GRACE VALLEY RANCH, PHASE 6

ADDENDUM #2

05/16/2025

C4.04

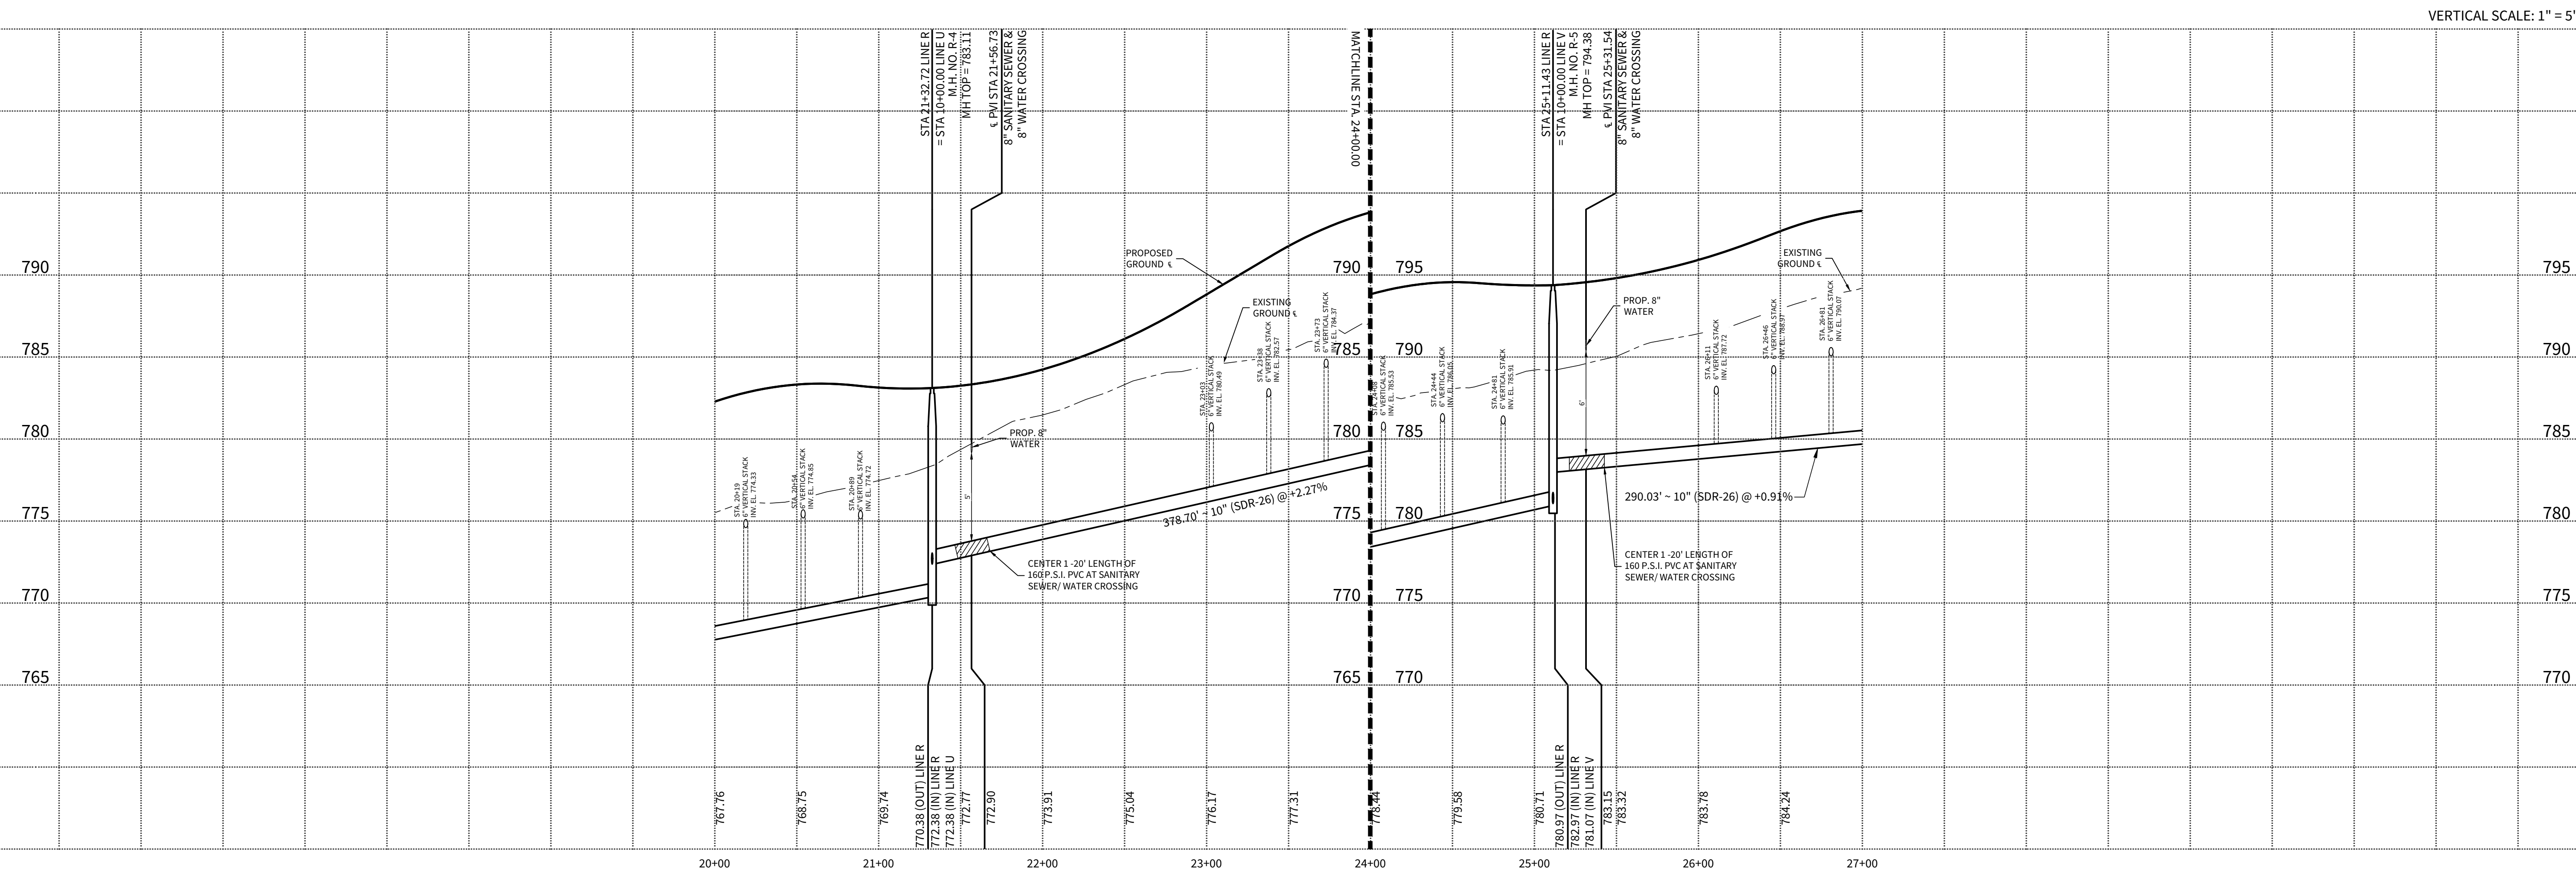
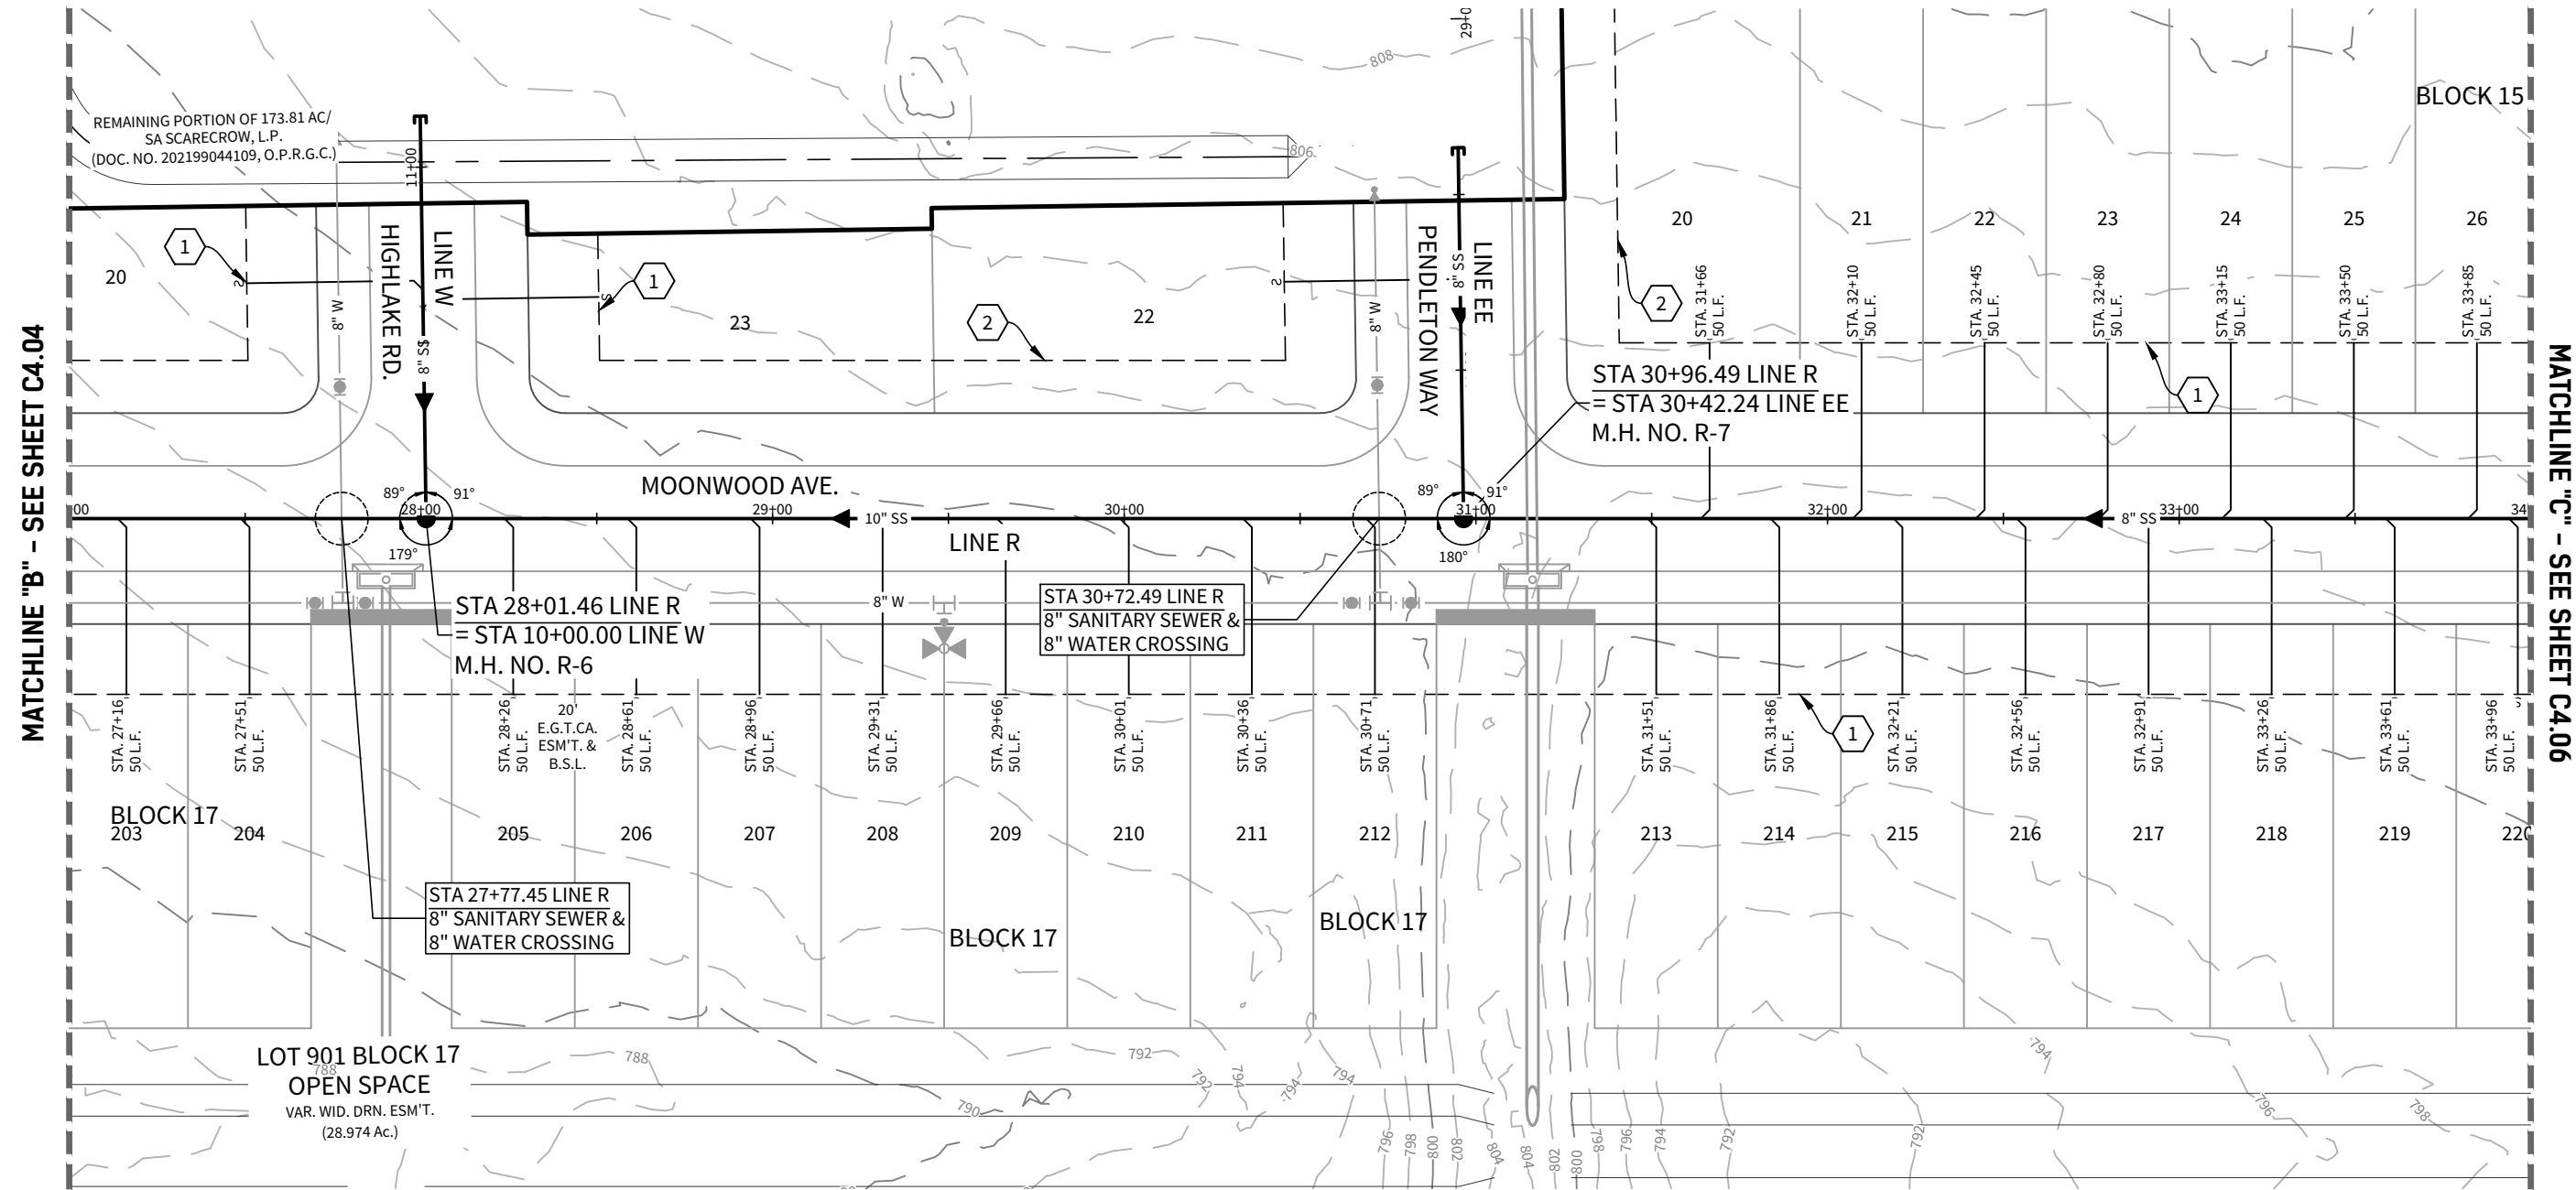
- Question 33** Bid tab calls for 10649 LF of 6" sewer lateral. Plans call for 10855 LF..
- Answer 33** *The Bid Form has been revised to correct the amount of 6" sewer laterals to 10,523 LF. Sheets C4.03-C4.07 have been revised showing correct lateral lengths. All corrections are included in Addendum #2.*
-
